19 November 2024

## **S99 AMENDMENT APPLICATION TO PDA APPROVAL FOR 83, 87, 93, 93A, 97, 97A, 101, 101A, 105, 105A, 109 AND 109A ALBERT STREET; AND 100, 100A AND 104 MARY STREET, BRISBANE (EDQ REF: DEV2023/1374)**

**Figure 3** – Comparison of approved and proposed plans (proposed changes outlined in red)

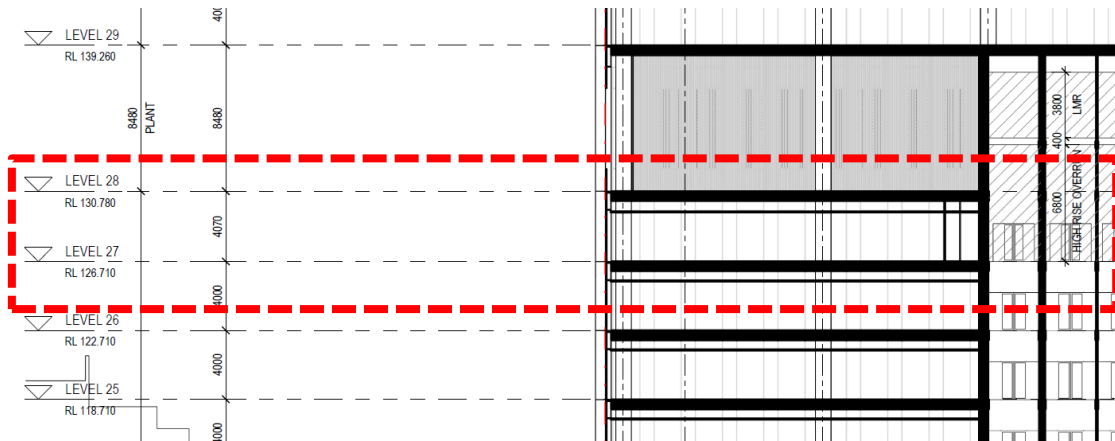
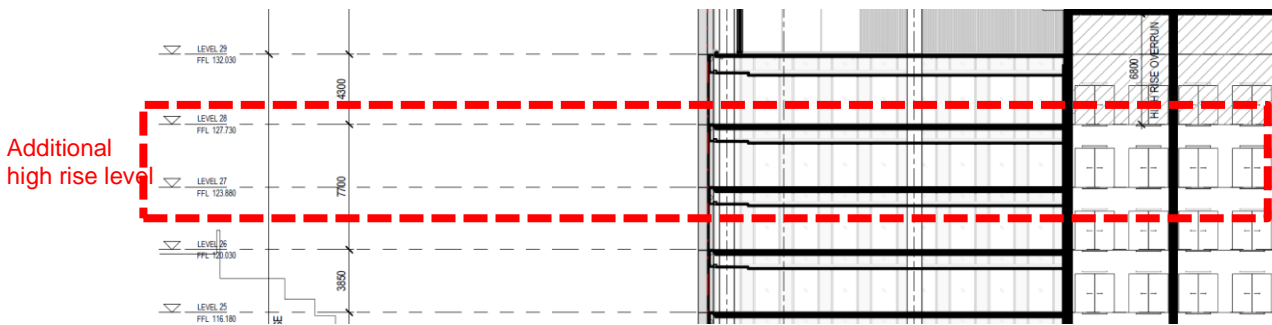
The first aspect of the proposed minor amendment involves increasing the building by one (1) additional storey, specifically within the high-rise level 27 and 28. An extract of the proposed additional high rise storey is illustrated in **Figure 3** below.

Whilst the revised proposal consists of one additional building storey, reduced floor to ceiling height on Level 7 and 8 (from 4000 to 3850mm) through detailed co-ordination allowed the introduction of the additional floor without impacting the approved height. The overall building RL of 185.130m remains unchanged.

**Figure 4** – Comparison of approved and proposed plans showing reduced floor to floor levels 7 and 8 to retain overall RL height

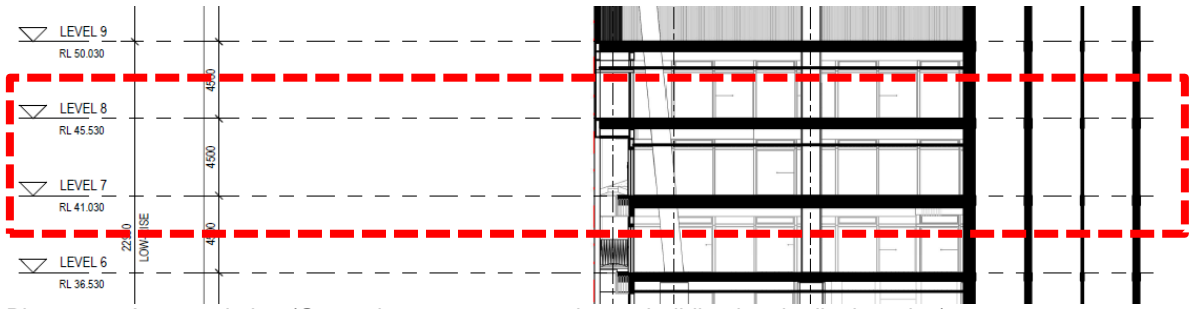
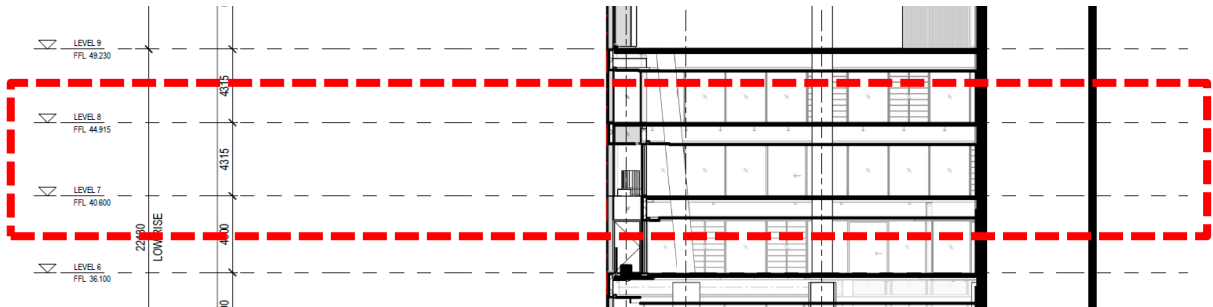
Reduced floor to floor level 7 & 8 to retain crown

Figure 5 – Overall comparison of approved and proposed elevation plans

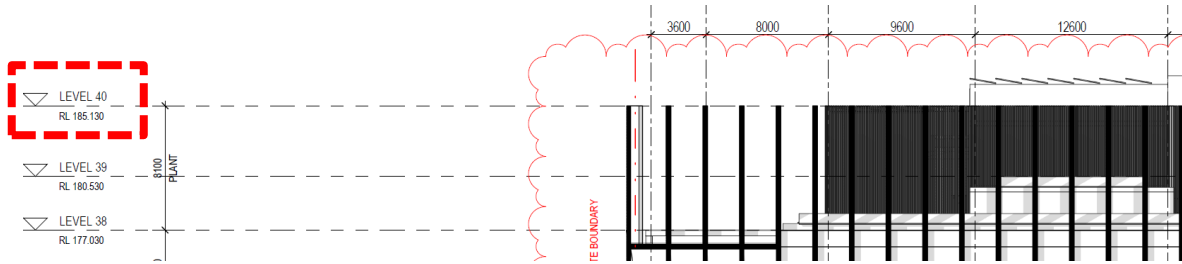
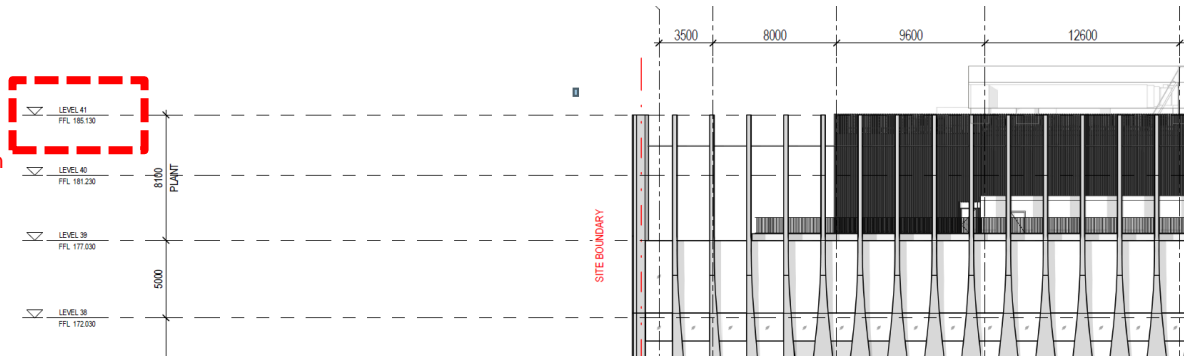
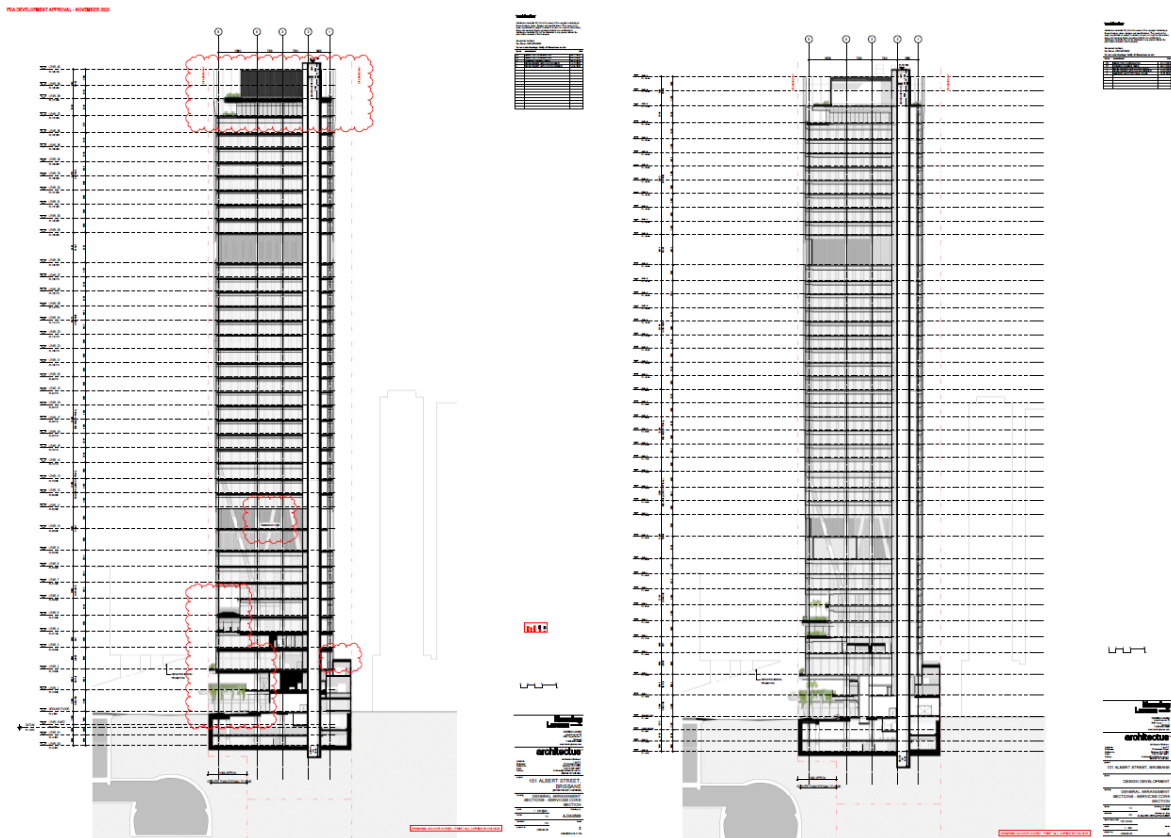
Despite the additional floor, the overall building appearance, bulk and scale is consistent with the current development approval. A further comparison between the approved and proposed elevation plans are shown in **Figure 5**.

Crown RL remains at 185.130RL align with approval

**Figure 6** – Comparison of the approved and proposed low rise plans (areas marked in red)

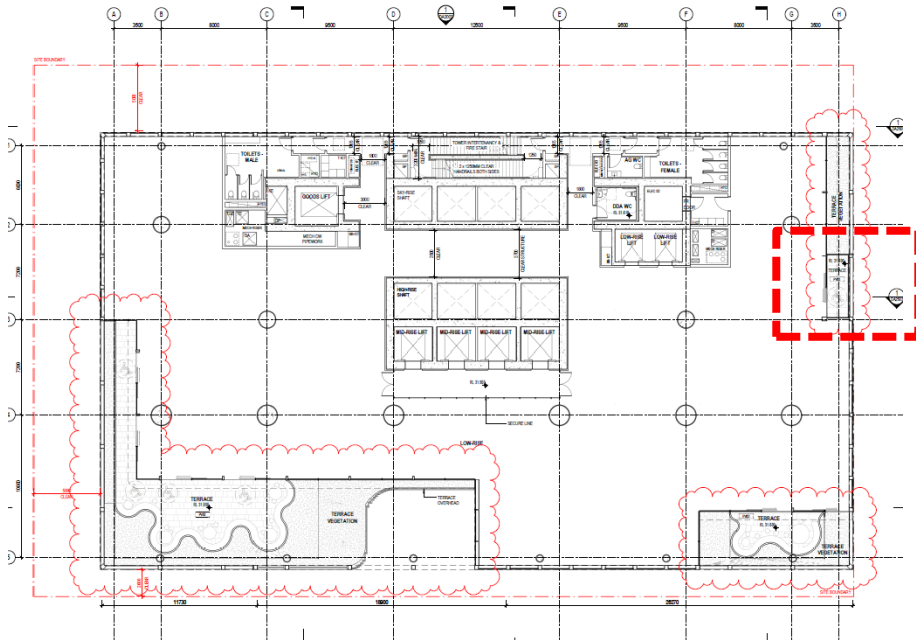
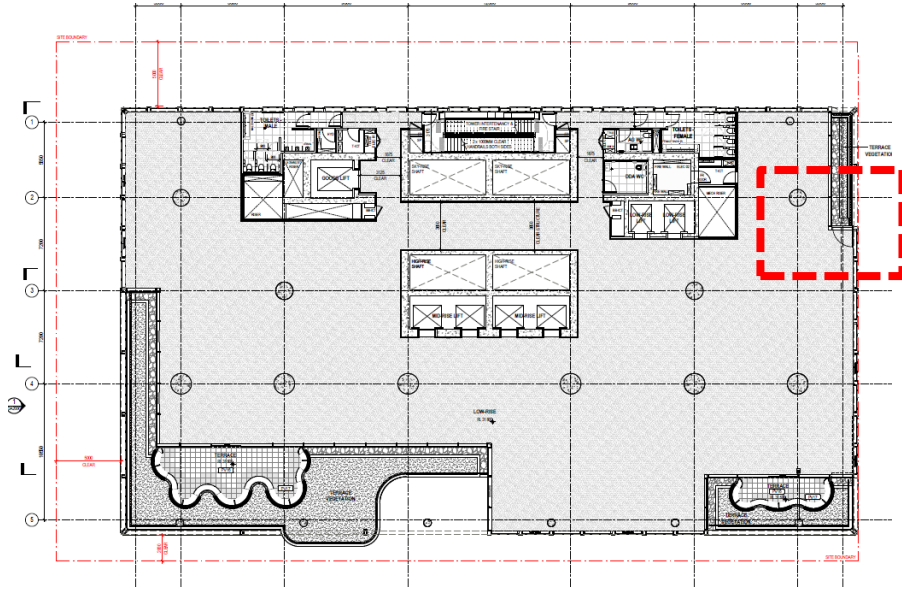
The second aspect of the proposed minor change involves solid cladding material updates within Levels 2, 5, 6 and 7 in order to align with the building’s façade glazing and GRC.

The proposed change is a result of the changes to the proposed material which has resulted in a minor increase to the projection of the overall building to ensure alignment with the approved vertical façade elements.

As illustrated in **Figure 6** below, the overall building bulk, scale and appearance remains unchanged and generally consistent with the approved building and will not be readily visible.

**Figure 7** – An extract of low rise comparison plans showing landscape to awning

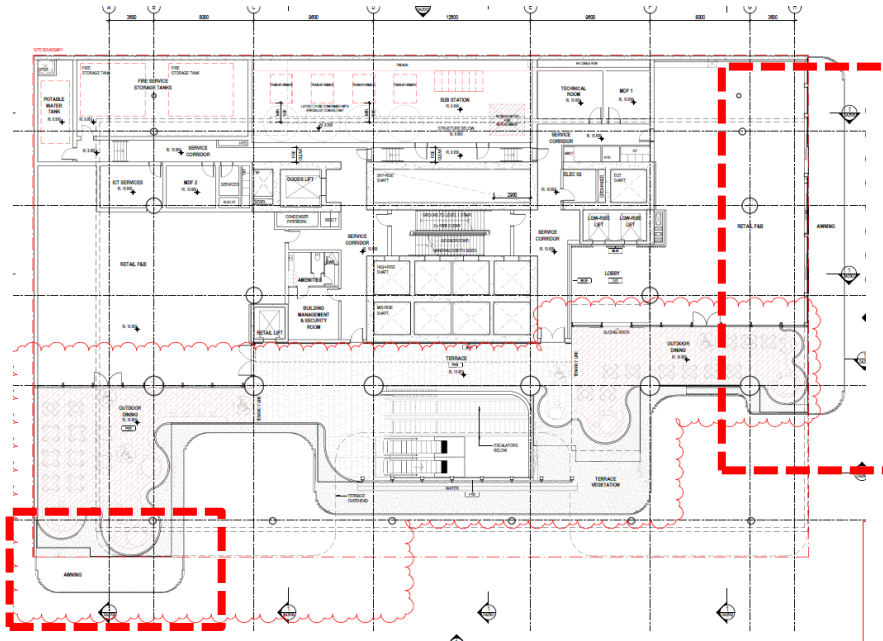
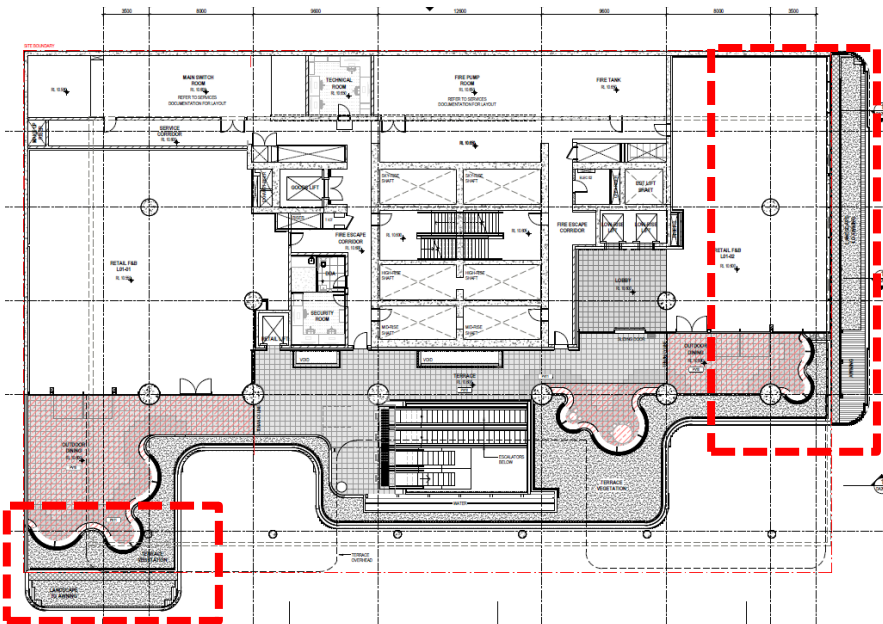
In terms of the landscaping design, it is proposed for the landscaping canopies to be included in the awning design over the footpath. The intent of this design is to provide some visual benefit to future tenants as well as provide additional landscaping to further soften the facade.
